**SAN ANTONIO WATER SYSTEM
CENTRAL WATER INTEGRATION PIPELINE
SEGMENT 5-1
SAWS Job No. 18-8612
SAWS Solicitation No. CO-00181**

**ADDENDUM No. 6
August 9, 2018**

SAN ANTONIO WATER SYSTEM
CENTRAL WATER INTEGRATION PIPELINE
SEGMENT 5-1
**54" PIPELINE
PLAN & PROFILE**
STA 195+00 TO 199+00

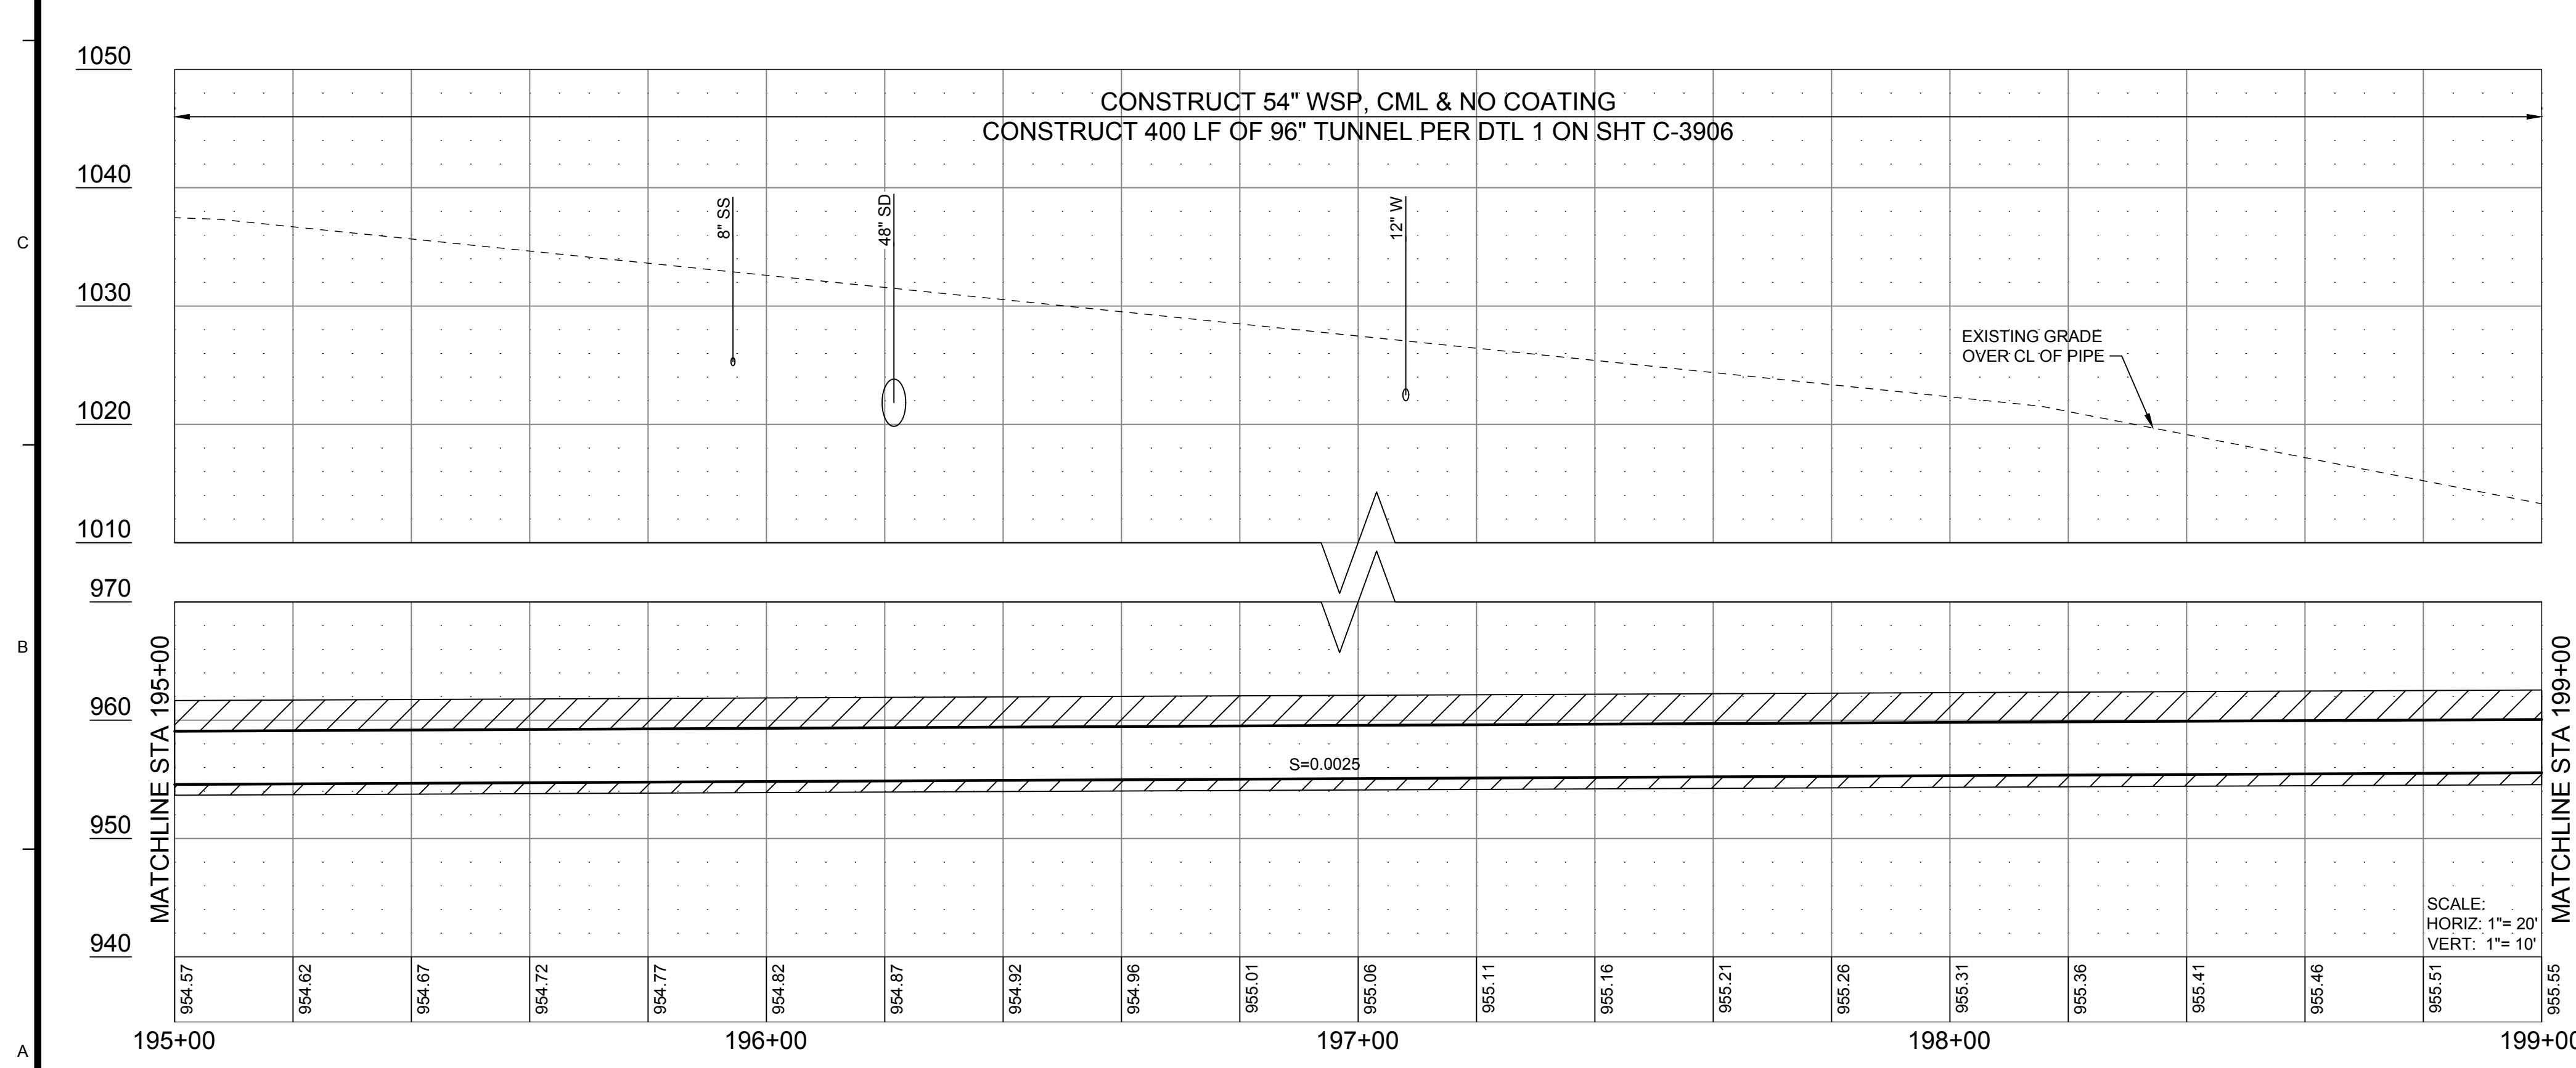
SHEET C-3125 – 54” PIPELINE PLAN & PROFILE STA 195+00 TO 199+00

- a) Delete Sheet C-3125 in its entirety and replace with the revised version included in this Addendum.

SAN ANTONIO WATER SYSTEM
CENTRAL WATER INTEGRATION PIPELINE
SEGMENT 5-1
**54" PIPELINE
PLAN & PROFILE**
STA 199+00 TO 203+00

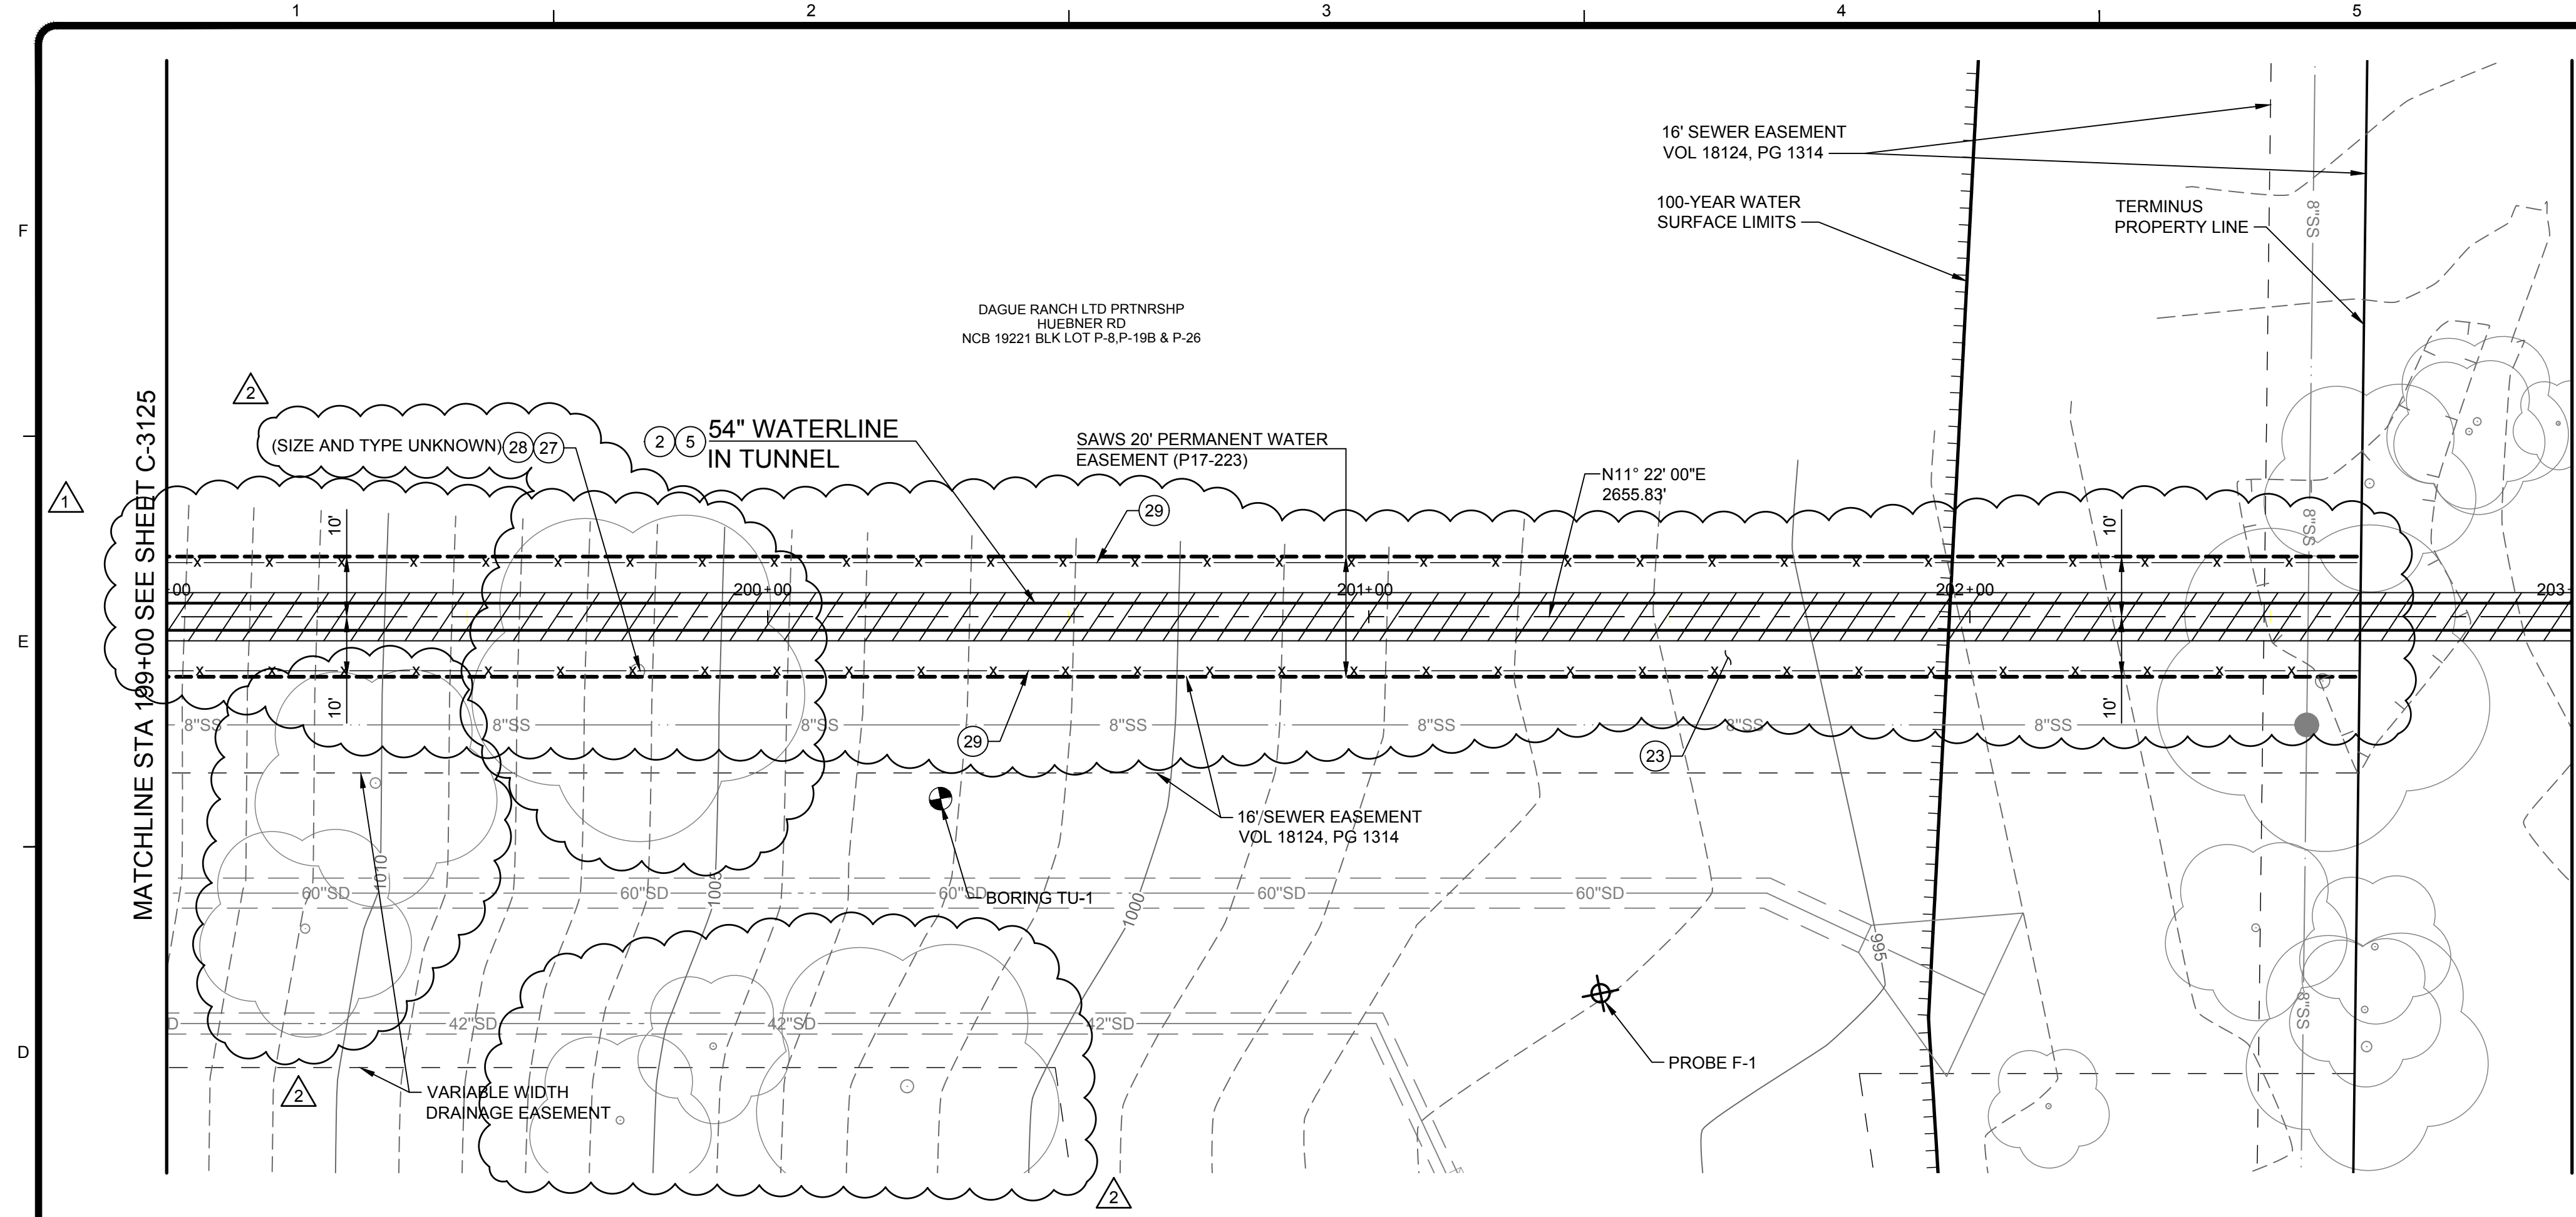
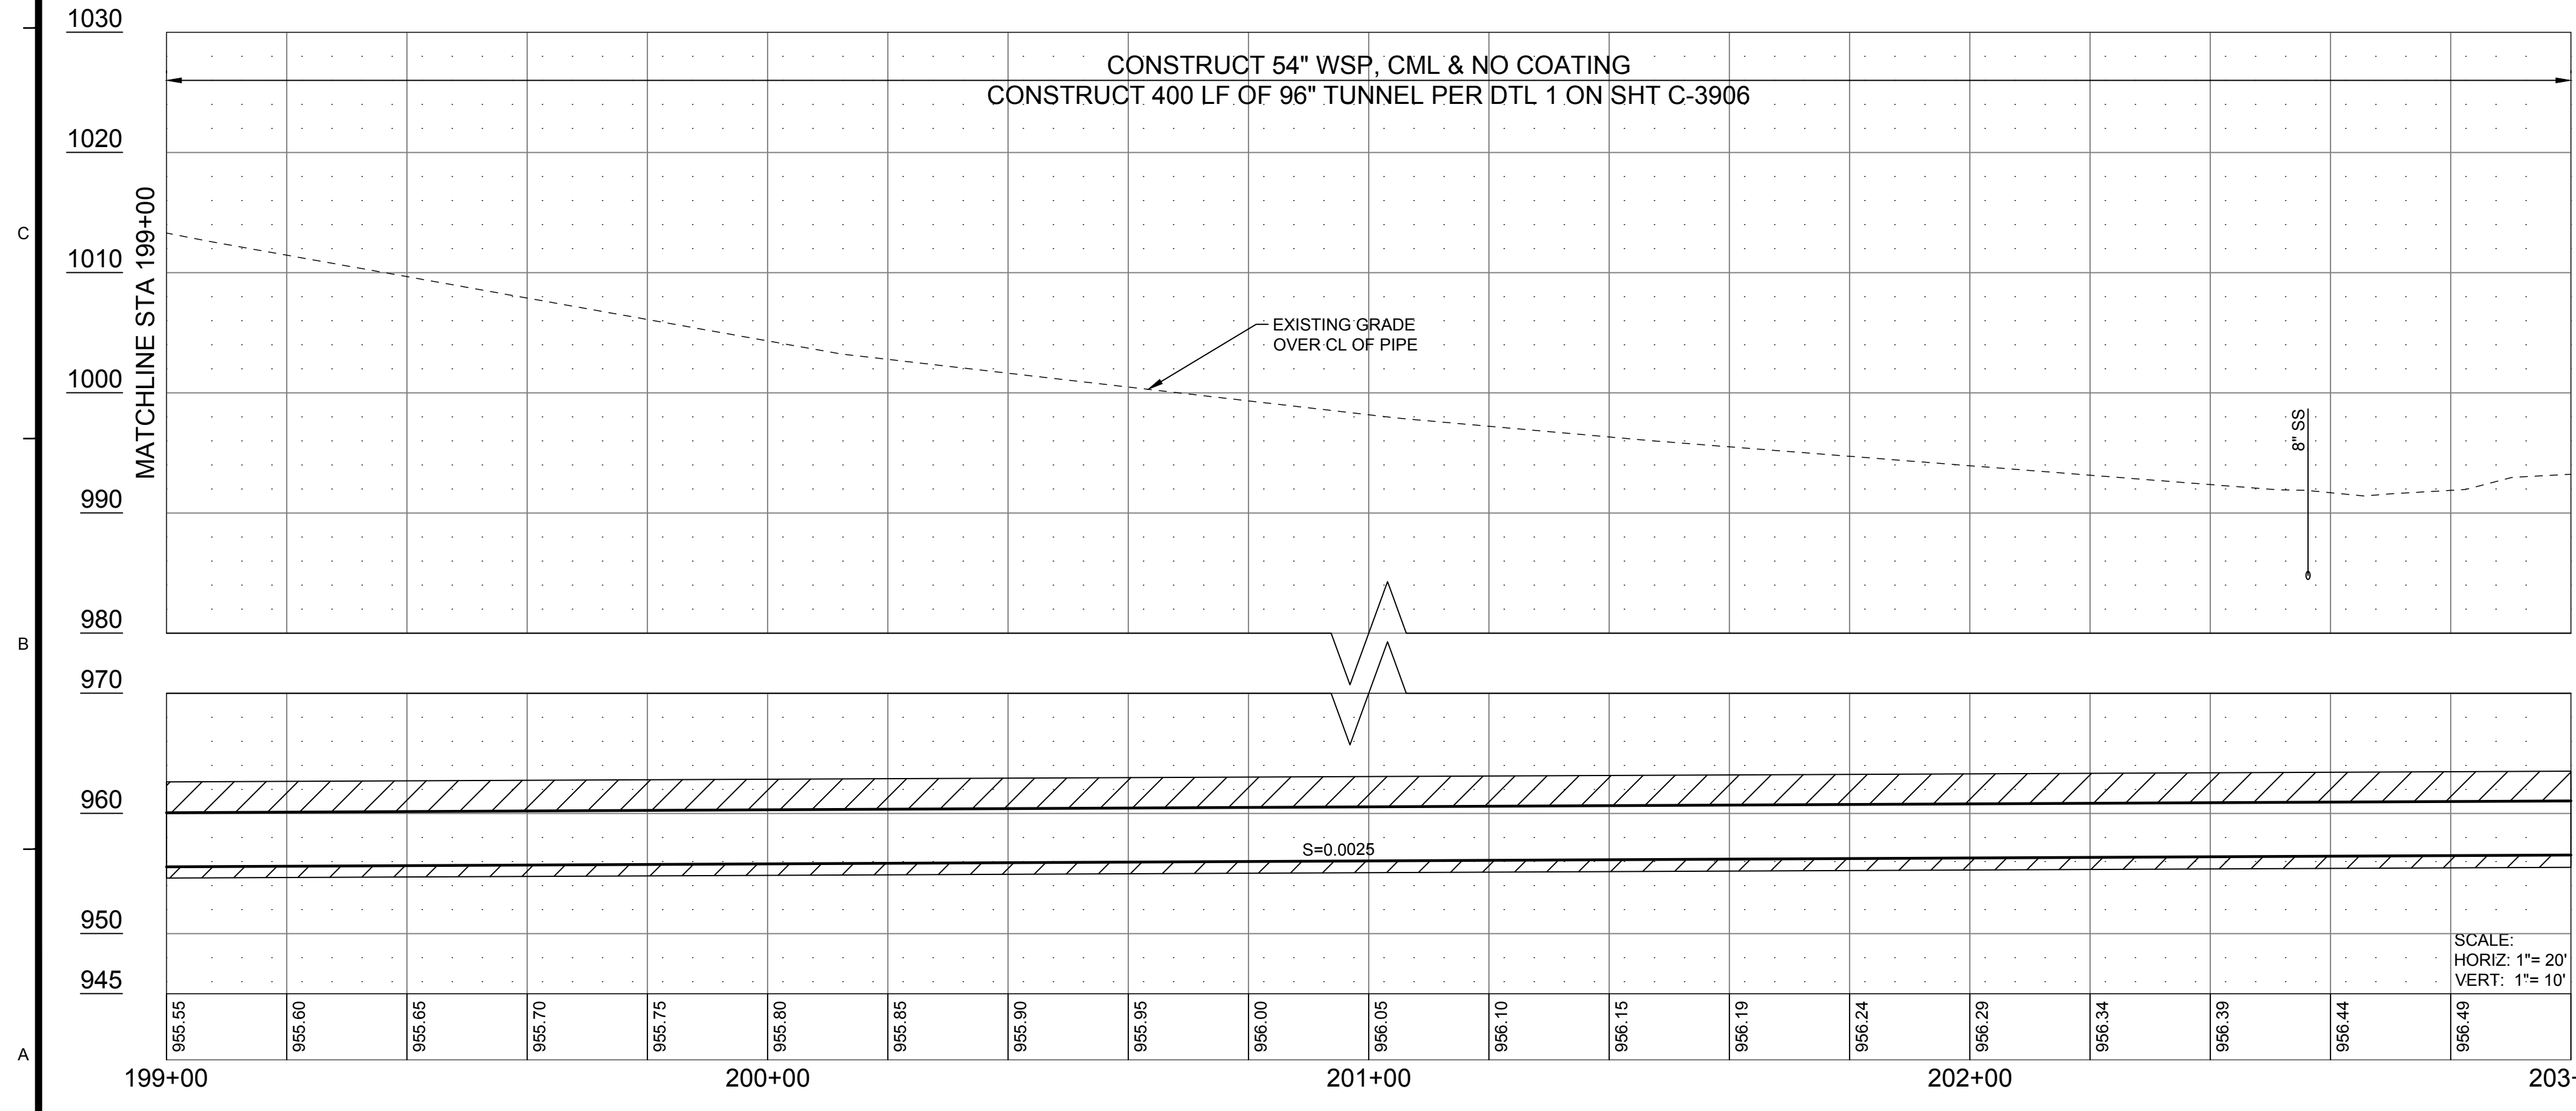
SHEET C-3126 – 54” PIPELINE PLAN & PROFILE STA 199+00 TO 203+00

- a) Delete Sheet C-3126 in its entirety and replace with the revised version included in this Addendum.
